COMMISSION ACTION

NCPC File No. Z.C. 07-13

**RANDALL JUNIOR HIGH SCHOOL REDEVELOPMENT
CONSOLIDATED PUD AND MAP AMENDMENT**
Square 643-S, Lot 801

STAFF RECOMMENDATION**NCPC File No. ZC 07-13****RANDALL JUNIOR HIGH SCHOOL REDEVELOPMENT
CONSOLIDATED PUD AND MAP AMENDMENT**
Square 643-S, Lot 80165 I Street, SW
Washington, D.C.

**SITE PERSPECTIVE LOOKING SOUTHEAST
(CORNER OF HALF AND H STREETS, SW)**

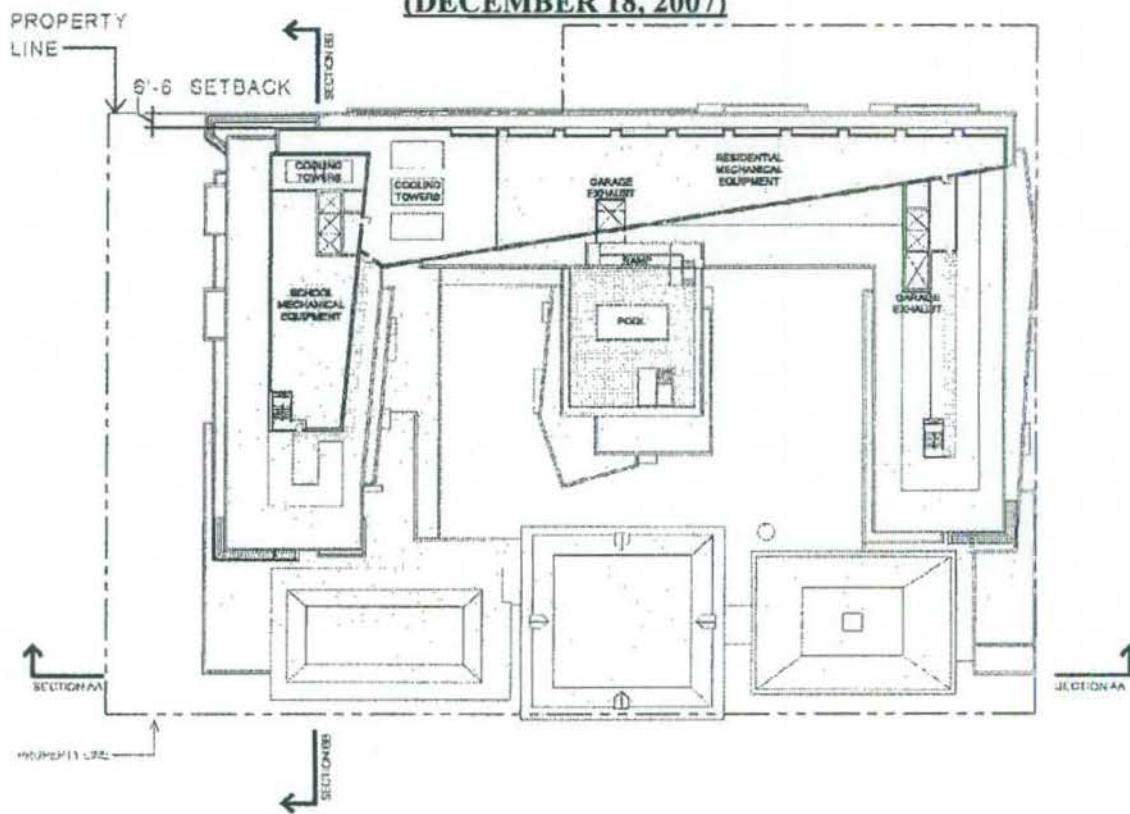
The northern mechanical penthouse is only setback six feet and six inches from the edge along H Street which is not sufficient, according to the Height of Buildings Act. Because the penthouse is not set back properly from the building wall, it is included in the overall height of the building, which is 116 feet, or six feet greater than the 110 feet that is permissible under the Height of Buildings Act for this project.

The developers of this property submitted revisions to their drawings at the December 10, 2007 Zoning Commission meeting and addressed the penthouse issue (see image on the next page, right). Their proposal at the December 10th Zoning Commission meeting was to redesign the northern penthouse by moving it back four feet from the facade. While the Zoning Commission proposed to approve the project with the four foot setback, they discussed increasing this setback to at least six feet. Zoning Commission members considered this six-foot distance in lieu of the four foot dimension because it is the difference between the actual height of the northern penthouse, which is 116 feet, and the allowable maximum height of the building under the Height of Buildings Act, which is 110 feet, the theory being that only the portion of the penthouse that exceeds the allowable overall building height need be set back. NCPC staff does not concur that this approach would meet the requirements of the Height of Buildings Act and maintains that the entire penthouse structure must be set back a distance equal to its height above the roof.

As staff believes that the conformance to the Height of Buildings Act issue has not been resolved by either the previous re-designs or the plans submitted on December 18, 2007, we recommend that the Commission comment to the Zoning Commission that the applicant should modify the design to set the penthouse back from the building wall to a distance equal to its height.

Recommends that the Zoning Commission require the applicant to modify the project design to setback the penthouse a distance from the exterior wall of the building equal to the penthouse height.
